APPENDIX D
REPORT OF DESIGN PANEL

The Design Panel was assigned the task of reviewing the design of the systems involved in the Apollo 13 accident, including their qualification history. The service history of the specific components flown on Apollo 13 was also to be examined from a design point of view to ascertain whether any abnormal usage experienced might have had a detrimental effect on the functional integrity of the components. The Panel was also charged with review of other spacecraft systems of similar design or function to ascertain whether they contained potential hazards. Finally, the Panel was to analyze, as required by the Board, proposed failure mechanisms to the extent necessary to support the theory of failure.

Figure D3-23.- Arrangement of electrical conduit.

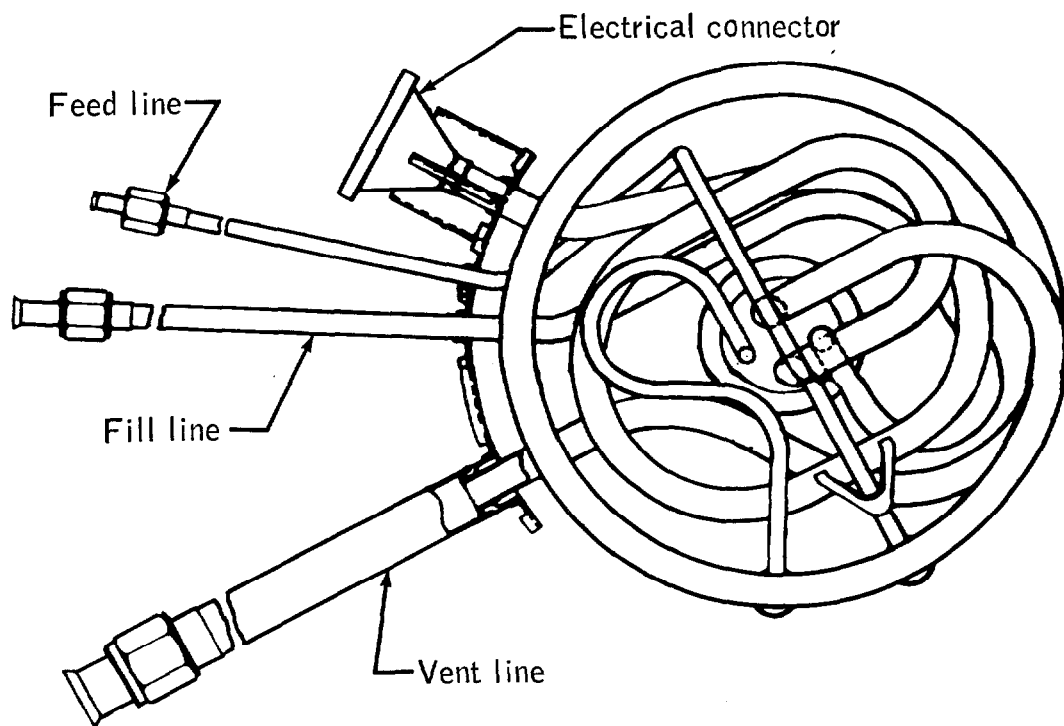
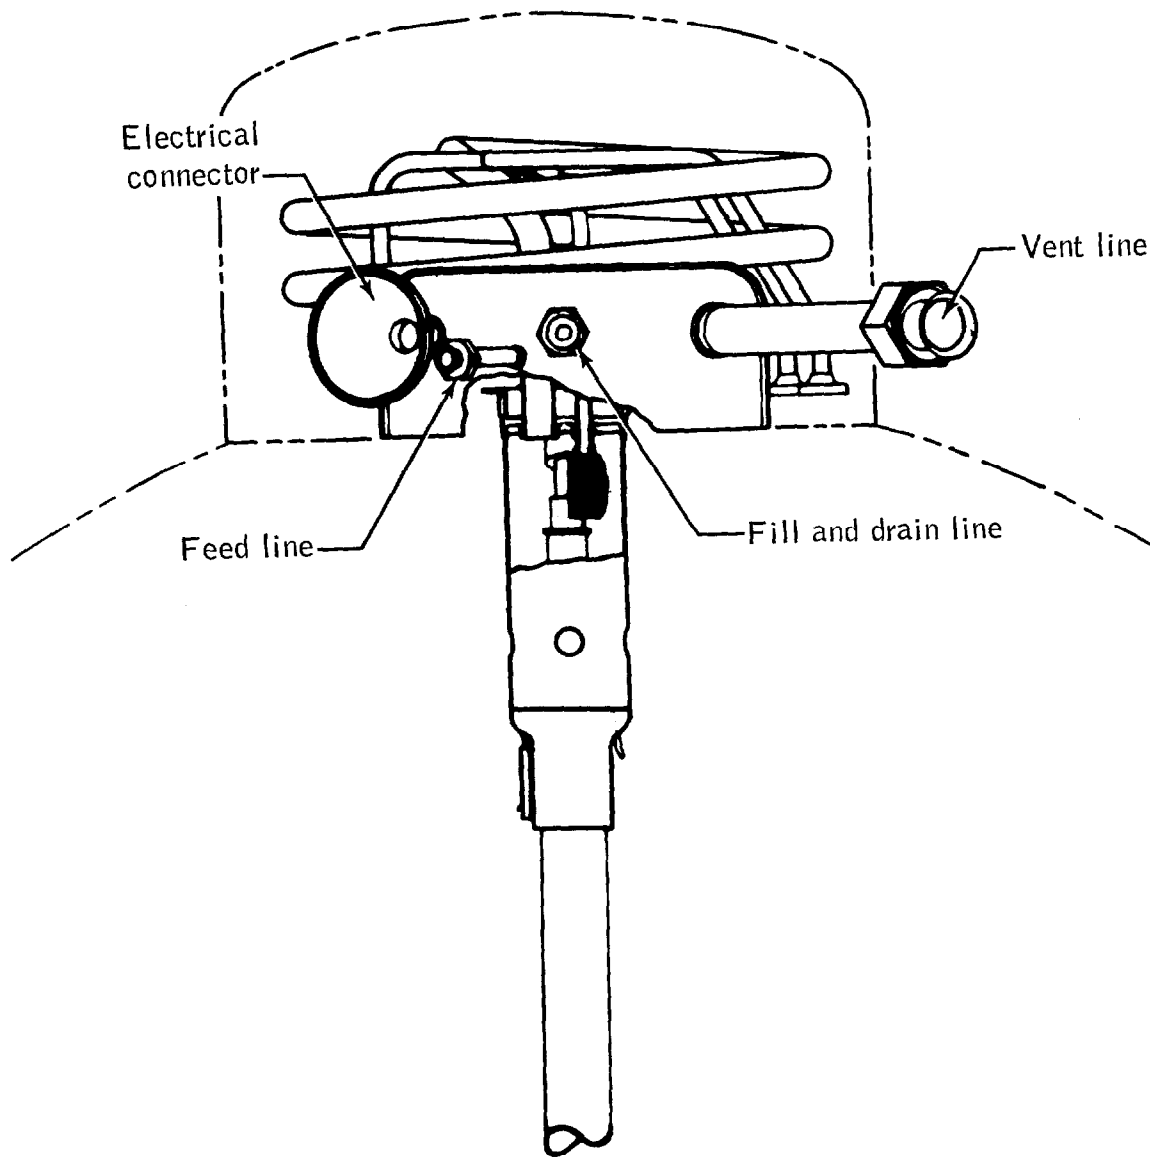
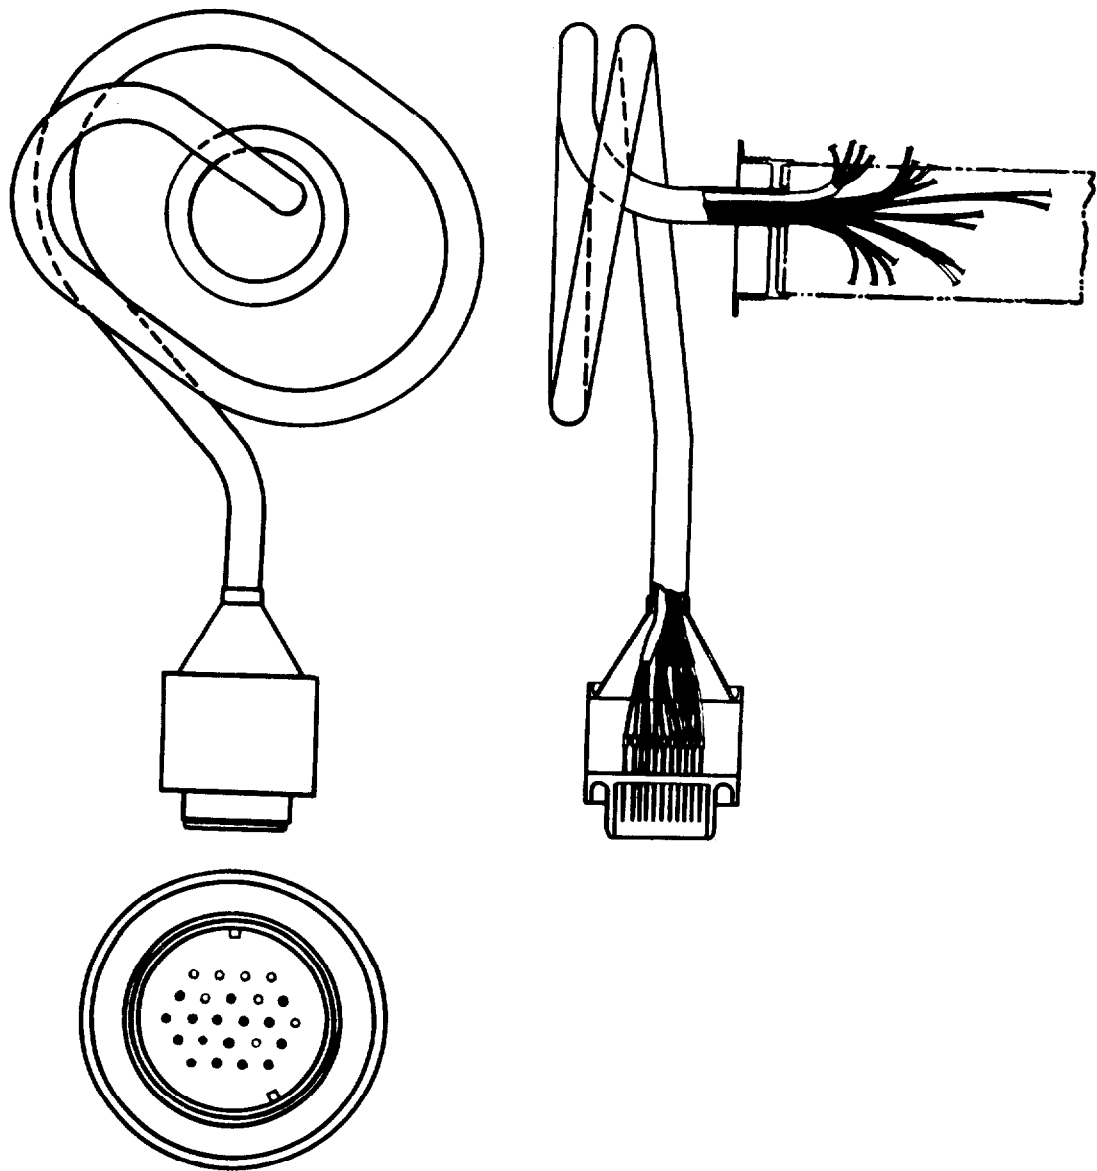
The design of this portion of the tank results in a configuration in which it is not possible to perform visual inspection of wiring after assembly. In consequence, the possibility of damage, in many cases undetectable by normal quality assurance procedures, is significant.
